Applicant: G. T. Mork and Company (Case 8440A&B-79)

Location: 7900 Cedar Avenue

Variance to Required
Exterior Surface
Material and Parking
Lot Setbacks
Case 8440A-79
Item 6.10

Case 8810A-80

SIGN DETAIL
SCALE 1/2" = 1'-0"

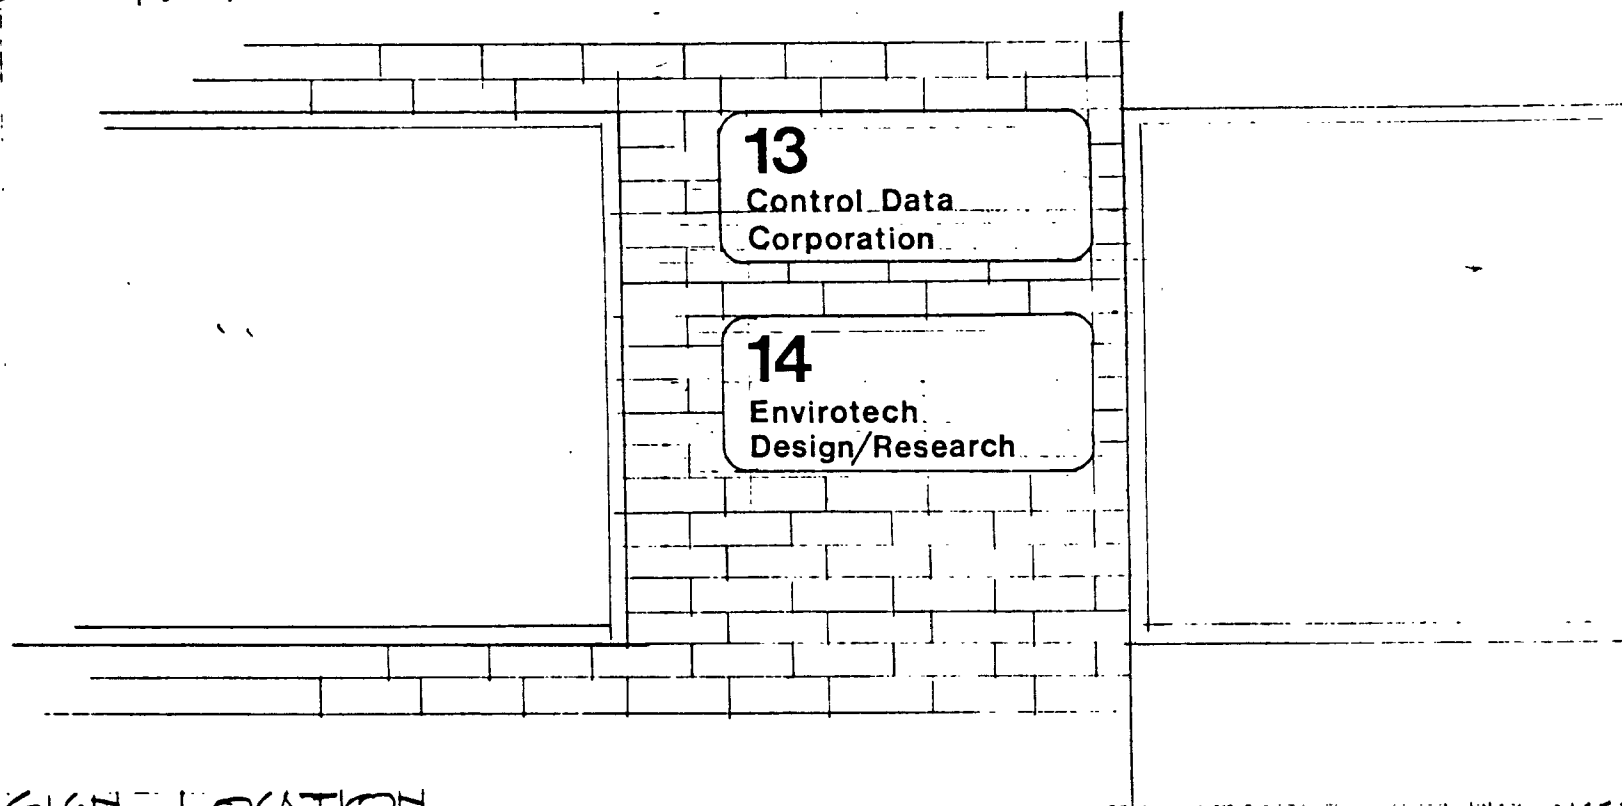
Staff would note that the master sight plan and planter/sign detail do not match up and that the former shows a 24-foot setback while the latter shows a 34-foot setback. These discrepancies should be corrected by the applicant.

- 1) sign size not to exceed four feet by 12 feet;
- 2) brick and letters to be approved by the Director of Planning; and
- 3) overall sign design for the development be approved by the Manager of Building and Inspection Division.
